**RESPONSE TO REQUEST FOR ADDITIONAL INFORMATION FOR LICENSE
AMENDMENT REQUEST REGARDING REALISTIC LARGE BREAK LOSS OF
COOLANT ACCIDENT ANALYSIS – RAI QUESTIONS 1 THROUGH 3
(NON-PROPRIETARY)**

**DOMINION NUCLEAR CONNECTICUT, INC.
MILLSTONE POWER STATION UNIT 2**

Millstone Unit 2 M5® Upgrade, Realistic Large Break LOCA Analysis RAI Responses

ANP-3316QNP
Revision 0

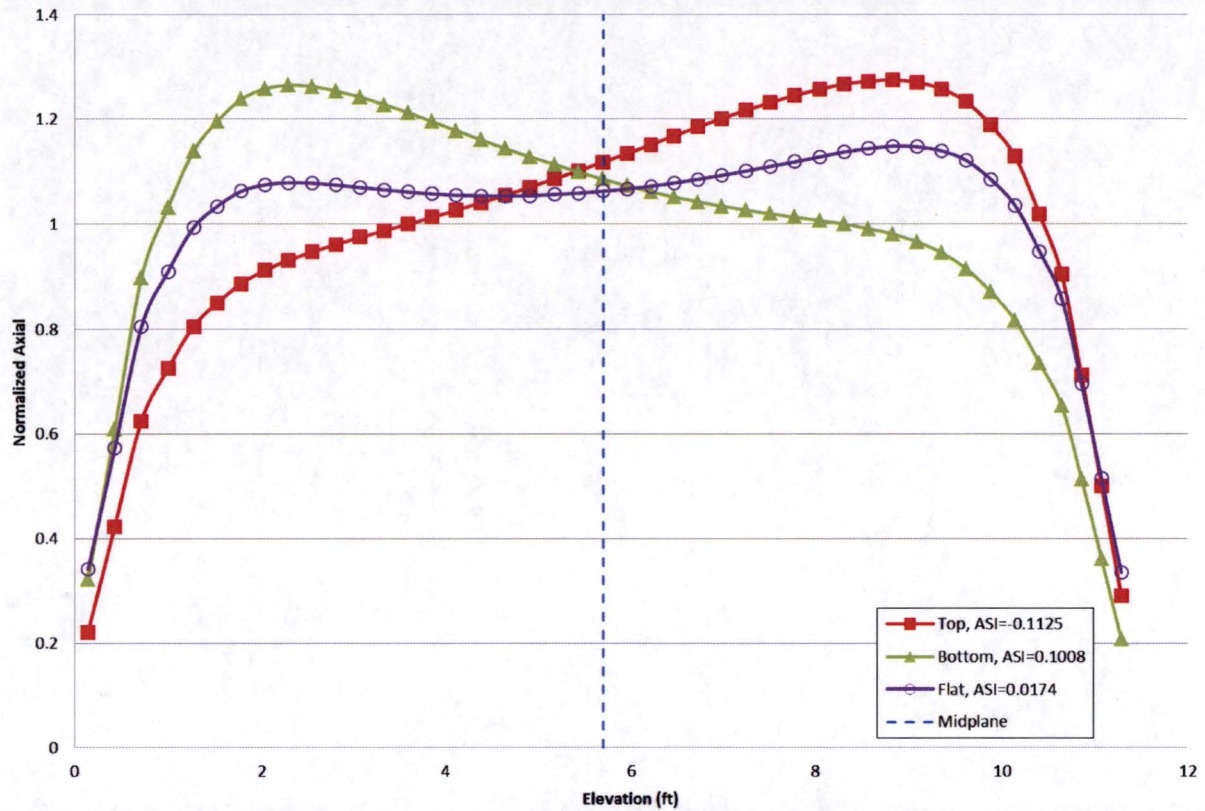
a) A strong trend was observed when reviewing the plot of the peak linear heat generation rate (PLHGR) versus the axial shape index (ASI). Please discuss how the PLHGR is used in the development of the axial power shape, why this strong trend exists, and how does this reflect physical plant operation.

b) There are several points that do not fall into the trend observed in Part a (e.g., point with sampled ASI of -0.0071). Please discuss if the plant can physically achieve these points or similar points that do not fall into the observed trend. If such points can physically exist during plant operation, please provide the maximum PLHGR the plant can achieve as a function of ASI over the range used in the analysis and please justify that the analysis results remain conservative.

Table A-1 of Reference [2] presents an “LHGR” value and an “ASI” value for each case. The LHGR value is equivalent to the sampled peak linear heat generation rate (PLHGR) and is a measure of the magnitude of power at the peak location. The ASI is the sampled fresh fuel hot rod axial shape index and is a measure of the difference between the power in the bottom half and the top half divided by the sum of the top and bottom halves. A plot of the PLHGR versus the ASI for each case shows the expected V-shape relationship between the two parameters: larger values of PLHGR values are associated with larger absolute ASI values. The V-shape relationship can be best explained using a plot of normalized axial shapes. Figure 3—1 shows an example of a top peaked shaped, a bottom peaked shape, and a relatively flat shape with their corresponding ASI values listed in the plot legend. As the axial shape becomes more skewed, the amount of power in the top or bottom region increases and the absolute value of ASI increases. As can be seen in the Figure 3—1, in order to skew the relative power in a region, the axial peaking increases and, accordingly PLHGR also increases.

However, PLHGR is associated with a single peak location in the rod, whereas ASI is a shape dependent indication of how the power is distributed over the full length of the rod. Because ASI is only a measure of relative power between regions, it is possible for shapes to have a moderate PLHGR and a low absolute ASI, like the case identified in RAI-2b.

During operation, the plant monitors the core power distribution in accordance with the Technical Specifications. It performs this function by continuously verifying that the core ASI and LHGR are maintained within the allowable limits specified in the Core Operating Limits Report (COLR). For the RLBLOCA uncertainty analysis, a set of axial shapes with ASIs supporting the plant's COLR operating bars and Technical Specification limits are generated. The process used in selecting the axial shape from those provided is described in Sections 9.3.1.3 and 9.3.1.4 of Reference [1]. The set of axial shapes is utilized in the sampling process and the selected axial shape is used without modification in the analysis. Accordingly, the relationship between ASI and PLHGR is maintained and that relationship is representative of plant operation.

All the sampled case axials in the analysis described in Reference [2] were derived from the axials provided for Millstone Unit 2. While larger PLHGR and, due to the relationship, larger absolute ASI values tend to result in more limiting PCTs, there are many other considerations and sampled inputs that will impact the magnitude of the PCTs. For instance, Figure 3 of Reference [2] shows the strong relationship of the PCT results to the break size input. The RLBLOCA method is a statistically based method and does not strive to make each case the most conservative result. The case-specific LOCA results are representative of the population of possible LOCA events for a given plant. From the set of all the case-specific results, the reported LOCA results are determined in order to provide a high confidence that the 10 CFR 50.46 criteria are met.
